MINUTES OF FSC 5935 CONNECTOR STANDARDIZATION PLANNING MEETING HELD AT DAYTON OHIO ON 25-27 AUGUST 1982(U) DEFENSE ELECTRONICS SUPPLY CENTER DAYTON OH 30 NOV 82 F/G 9/1 1/2 AD-A130 681 NL 1 UNCLASSIFIED

SUBJECT: Minutes of FSC 5935, Connector Standardization Planning Meeting

FSC 5935 STANDARDIZATION PLANNING MEETING MINUTES

25 - 27 August 1982

INSPECTION HOLE TOLERANCES

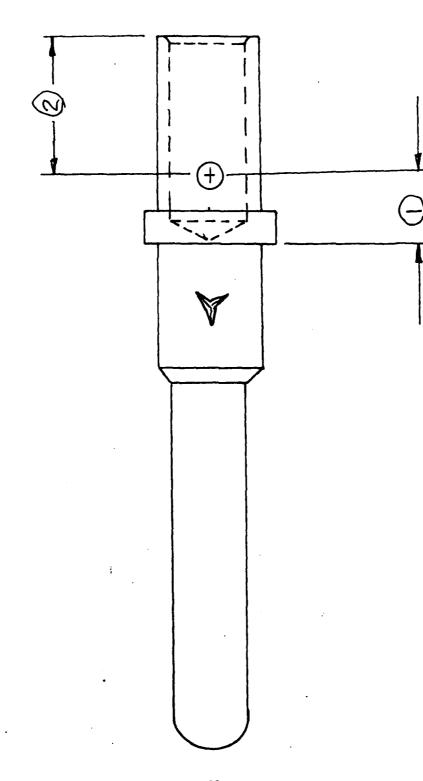
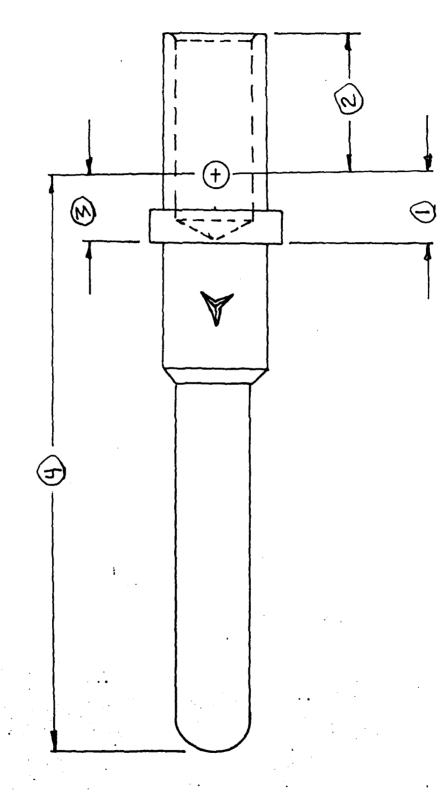
COMPILATION OF COMMENTS	COMMENT HUMBER	PROJECT HUMBER
COMPILATION OF COMMENTS COMMENTOR IND NAME OR CODE_Tri-Star Electronics [] A [] N [] AF [] ESSENTIAL [X] SUGGESTED [] MFR [] USER [] IND ASSOC [] DESC. [] CAMESA Dimensions from M39029 specification We find that there are inconsistent crimp barrel bore depth. They ran or in other cases a .050 tolerance of .250 minimum, .236 minimum, .20 We suggest the standardization of uniformity within connector family sizes.	necomme [] ACCEPTANCE [] NON-AC [] MODIFY [] WITHDRAW [] on sheets (crimp becies in the dimense from the .010 de to unilateral tol 9 minimum and .141 these dimensions to	arrel bore depth) ions of the imension erances minimum. o effect
DISPOSITION. [] ACCEPTED [] NON-ACCEPTED [] WIT	HDRAWN [] MODIFIED	
DESC FORM 155		
FED 14 PREVIOUS EDITION WIL	A DE USED	
COMPILATION OF COMMENTS	COMMENT HUMBER	PROJECT HUMBER .

DUE TO BREAKTHROUGH, THIS SLASH SHEET WAS GIVEN ±.0075 TOLERANCES

D. /90 & /91 WILL BE ADDED AT A LATER DATE
